Product change notification (PCN)

Title / short description	PSM-ME-... serial converters, change of color, QR code, packaging
Affected article category	Industrial communication technology
Change category	Material, Packaging
Change number	CDN240072-01
Reason for PCN/PDN Revision	Additional change of packaging

Change of housing color, QR code, packaging

old design

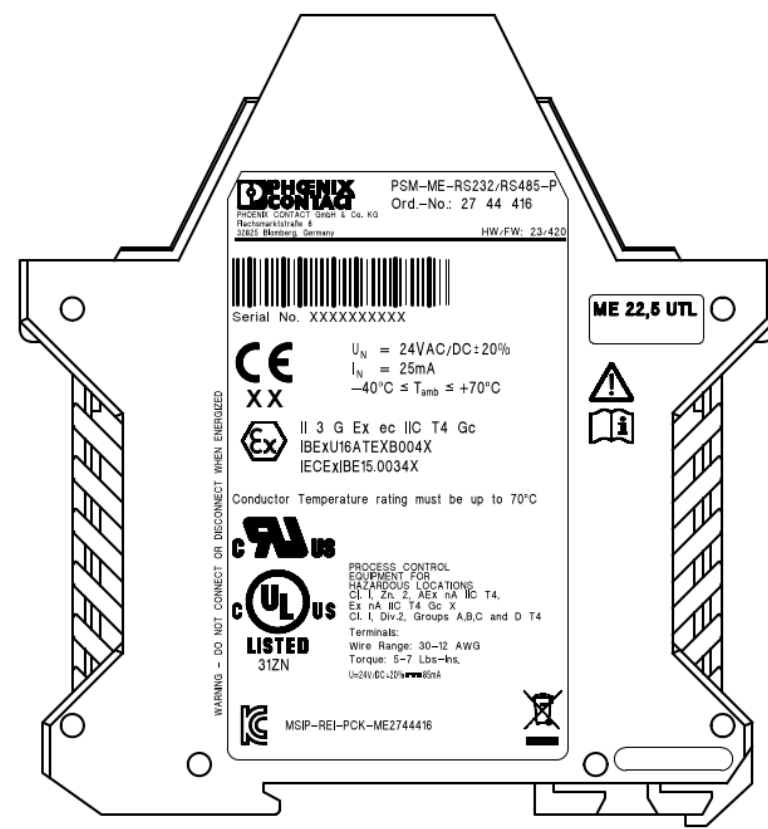
Additional information: New QR code
